TEC COAL PTY LTD

31 JANUARY 2019

ENVIRONMENTAL INVESTIGATION REPORT

RESPONSE TO
NOTICE
REQUESTING
FURTHER
INFORMATION

Figure 3.3 Map of sampling points W2 and SW16

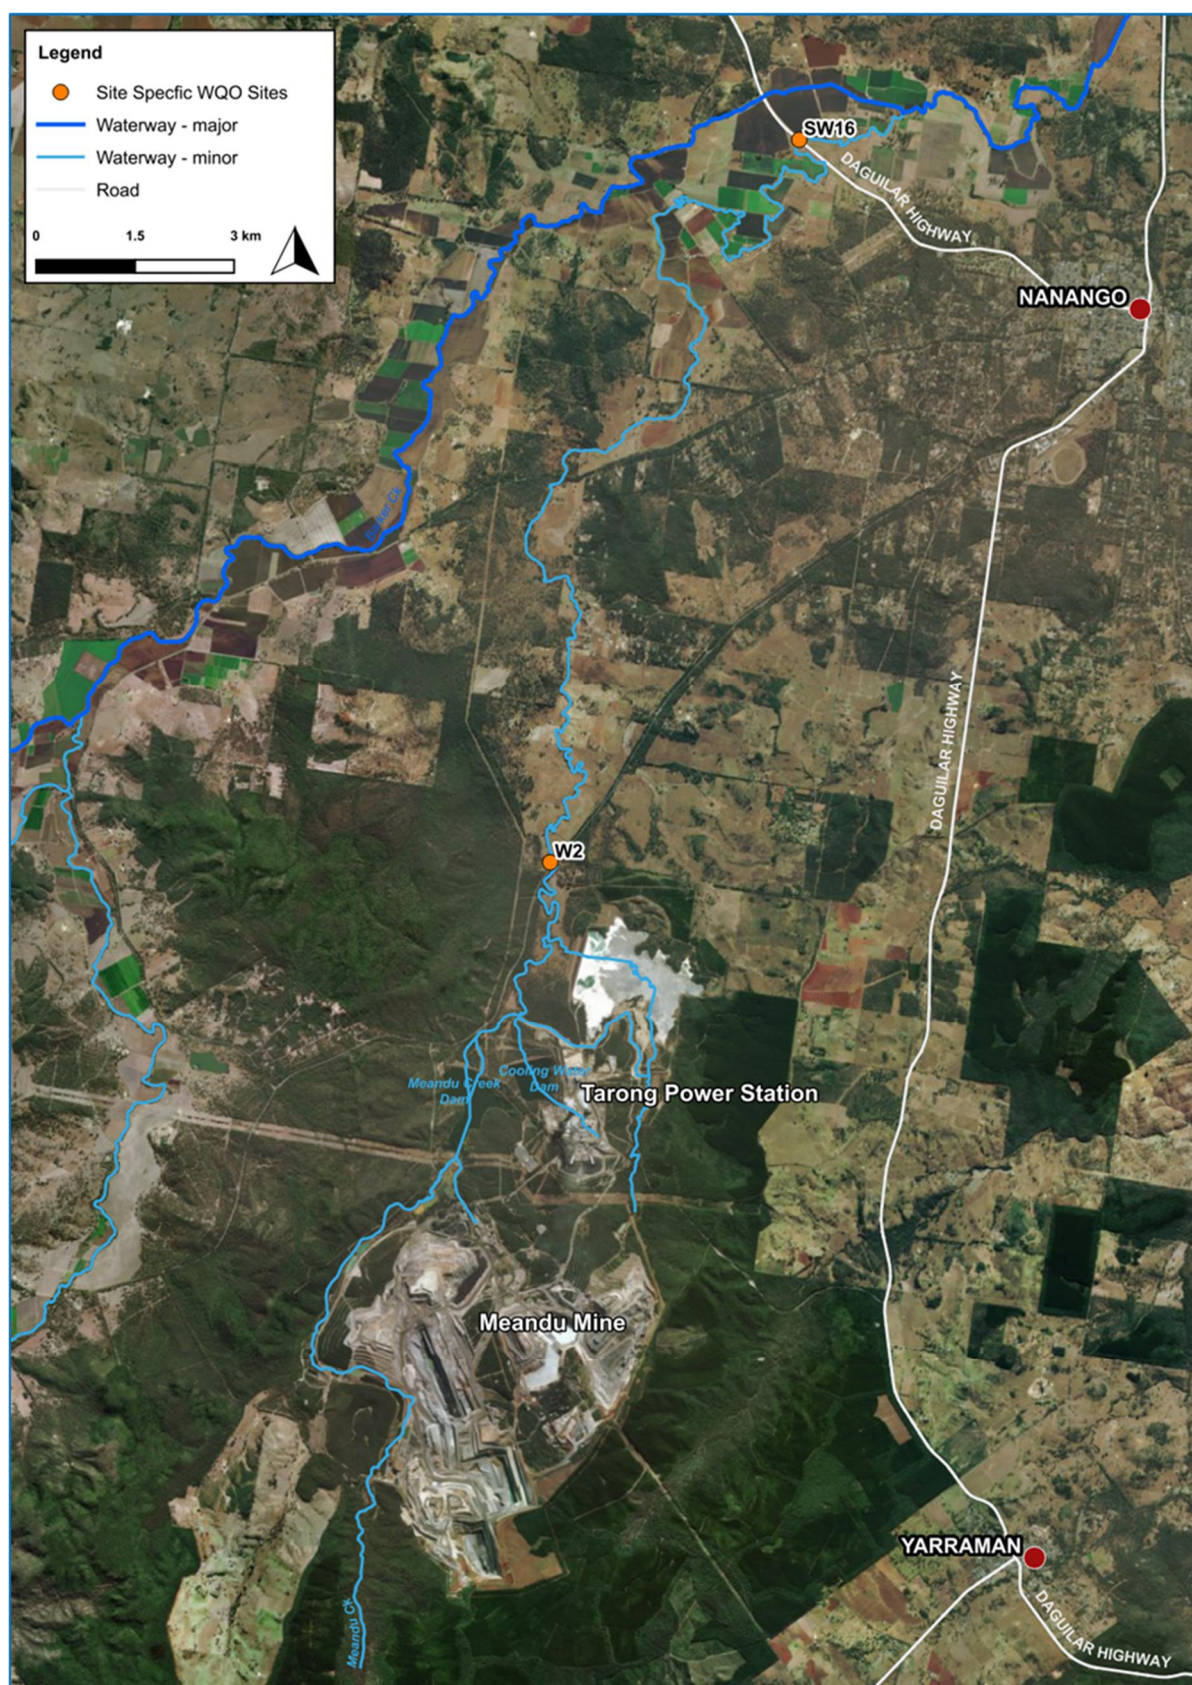
The location of sampling points W2 and SW16 were presented in Figure 7.4 of the EIR.

The location of sampling points W2 and SW16 are represented in Table 3.1 and Figure 3.3.

Figure 5.3 Waterway sites sampled during the March 2017 field survey

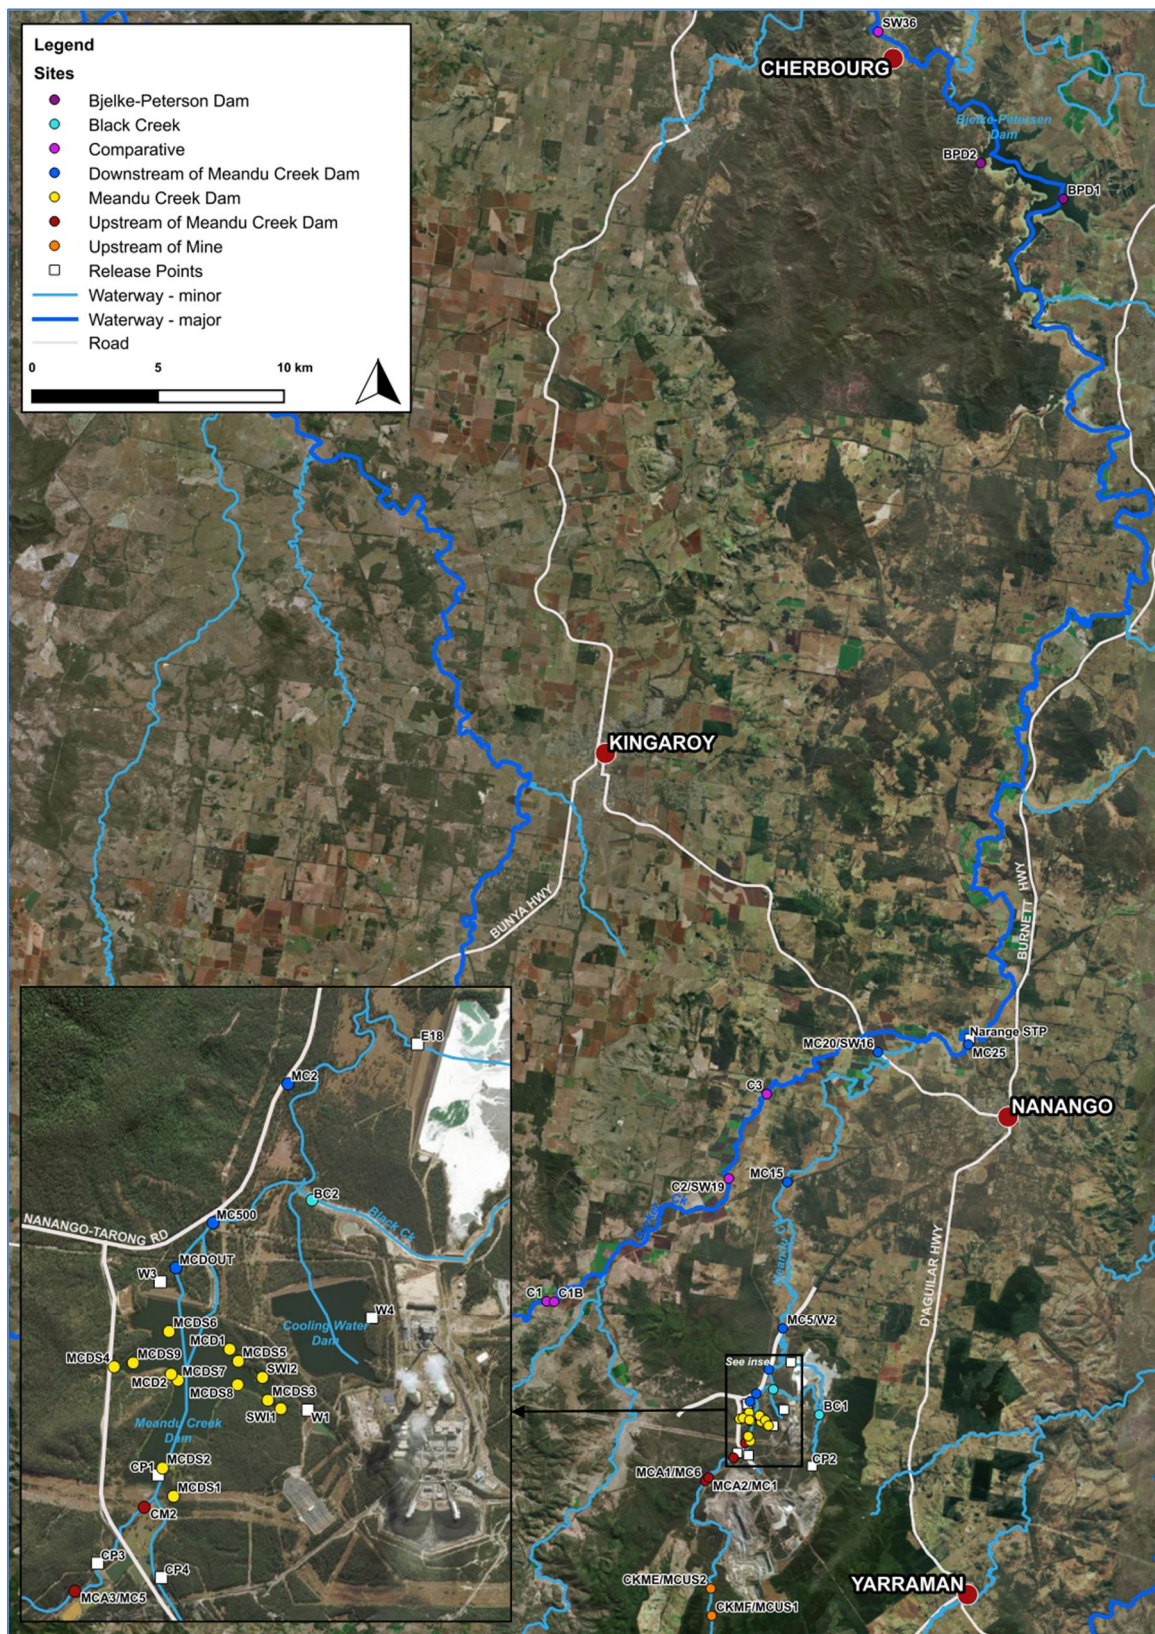
Figures 7.1 and 7.4 of the EIR and Figure 2.1 and 2.2 of Appendix G: Surface water quality investigation report of the EIR.

Revised maps displaying consistent labels (specifically labels for sites CKMF/MCUS1 and CKME/MCUS2) between figures in the main EIR report and Appendix G are presented in Figure 5.2 and Figure 5.3.

Figure 1 pH in water at sites on Meandu Creek from a) 1984 to 2006 and b) 2007 to 2017

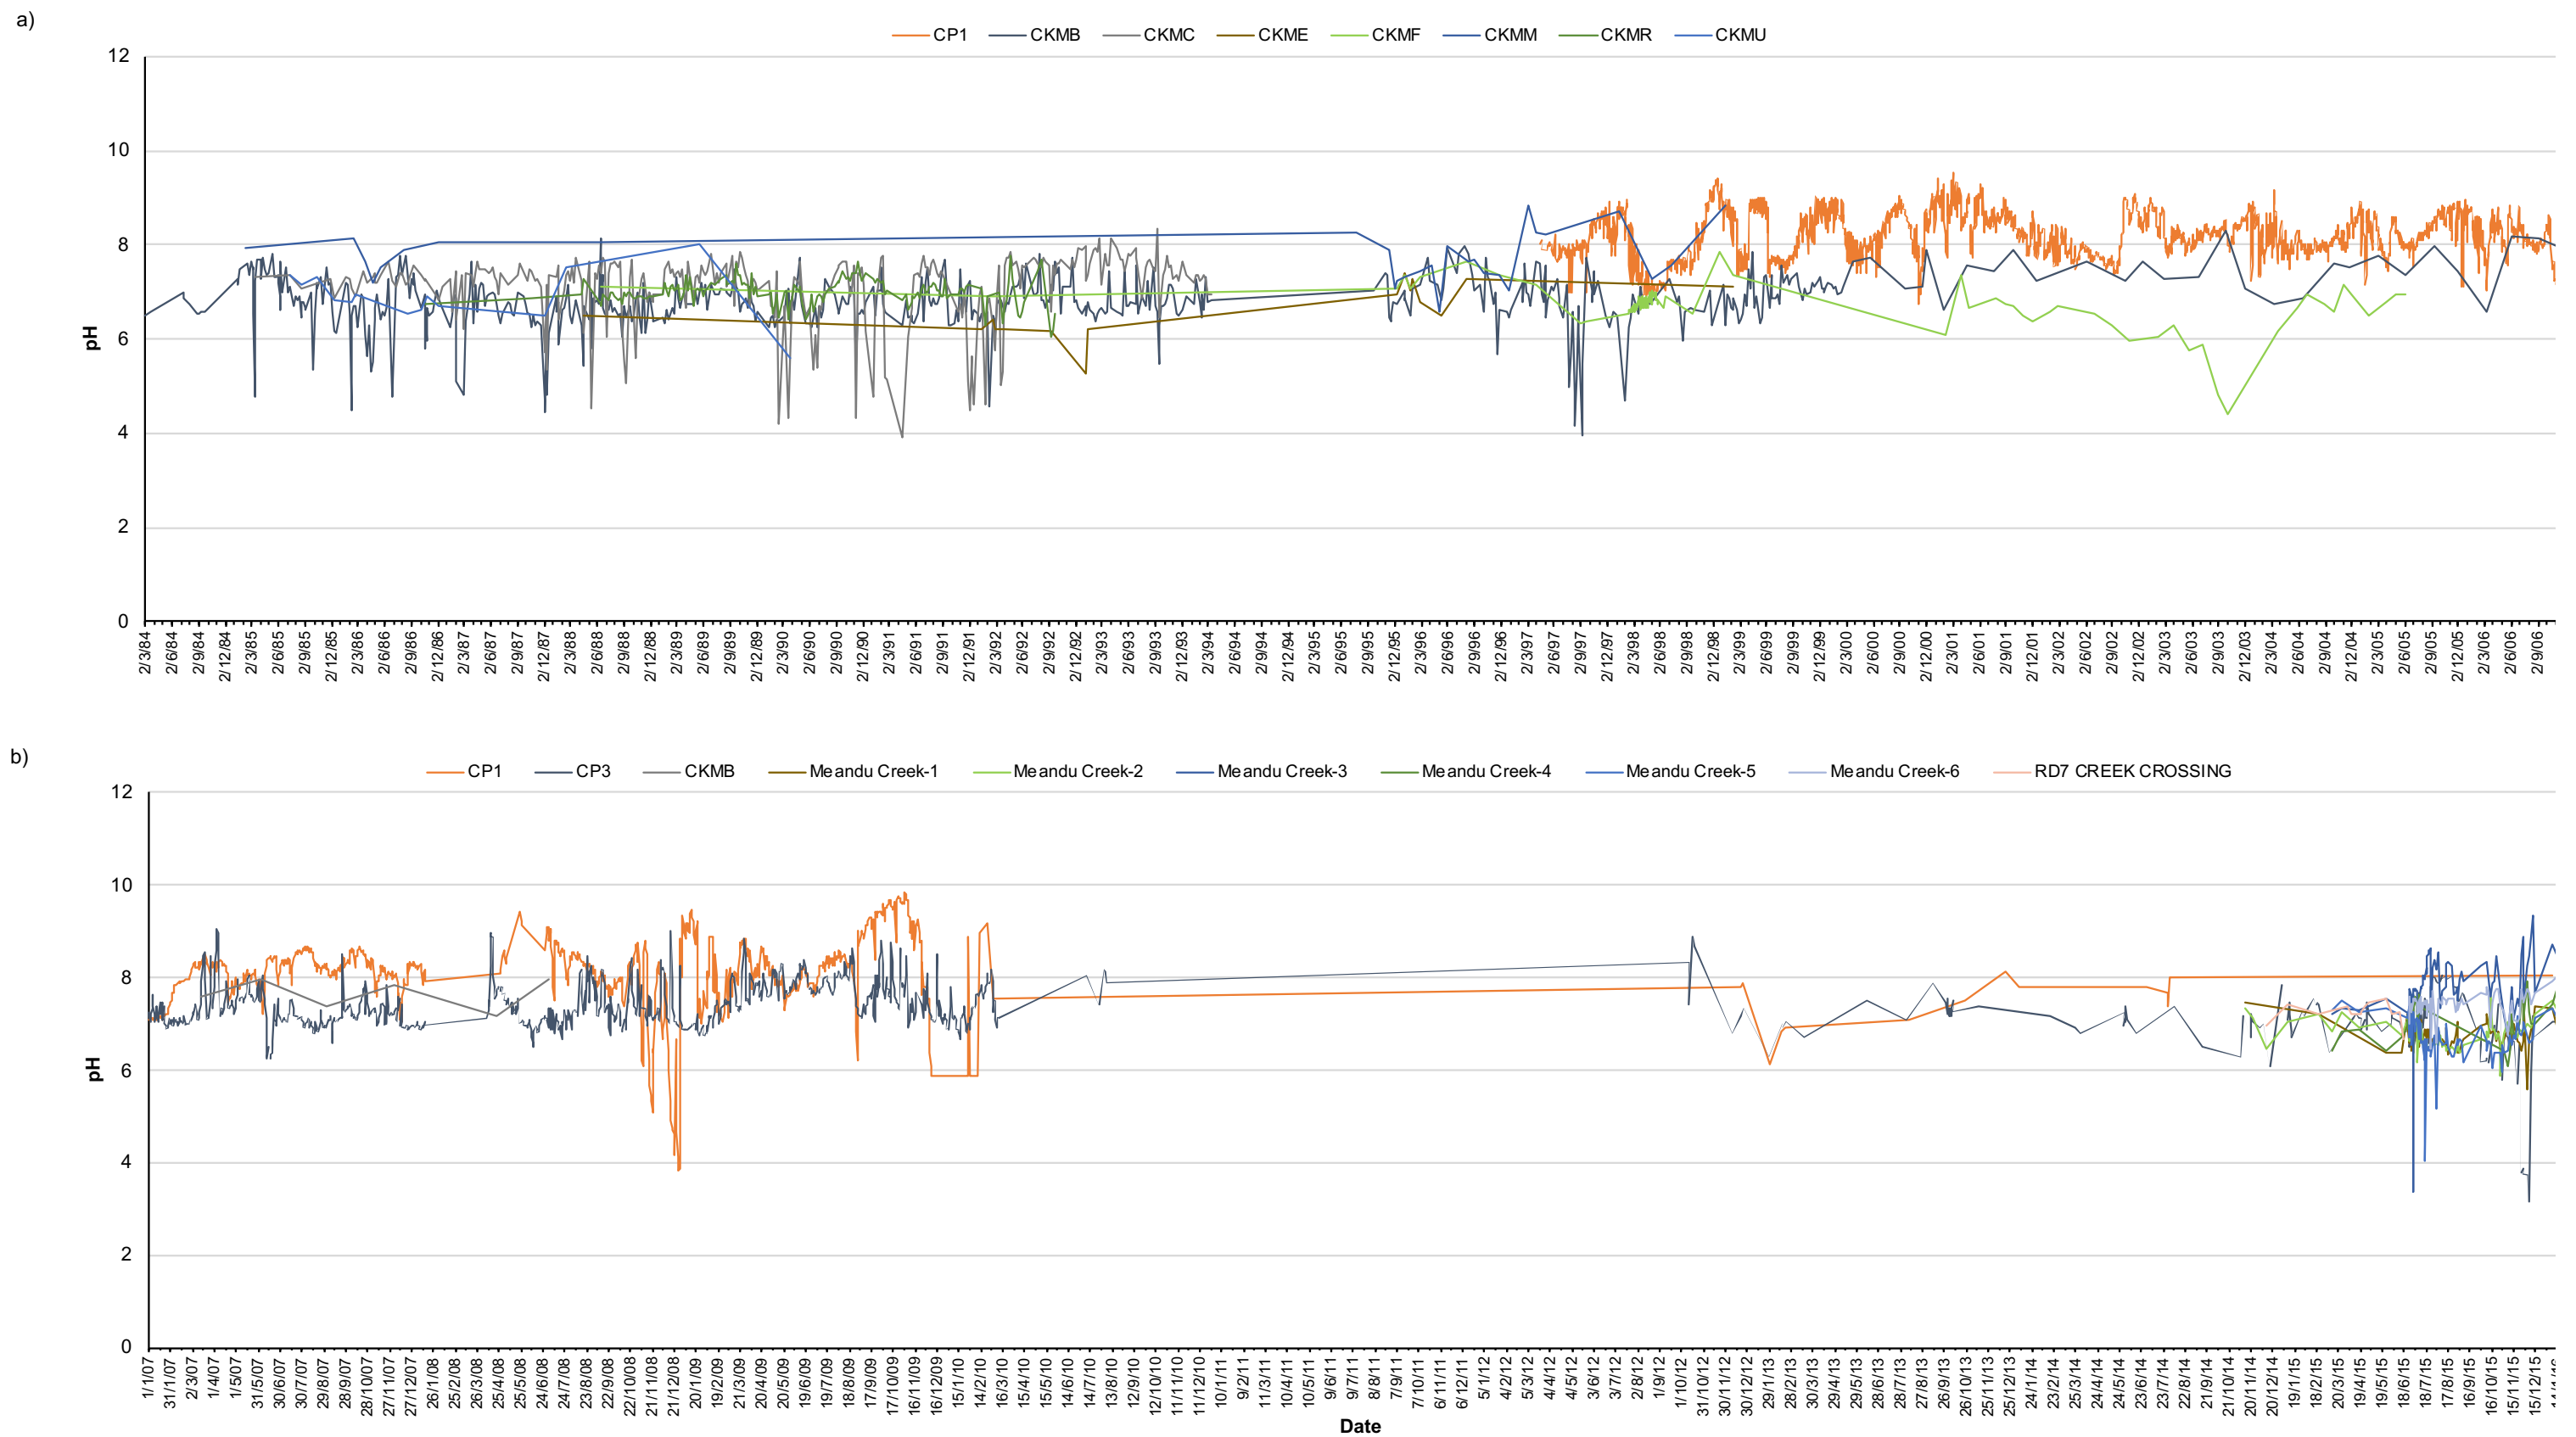
Revision of the water quality data presented on Figures in Section 7 and Appendix G of the report to ensure the data is clearly legible and at a scale that can be read (e.g. Figure 7.2 and Figure 7.8).

REVISED WATER QUALITY FIGURES
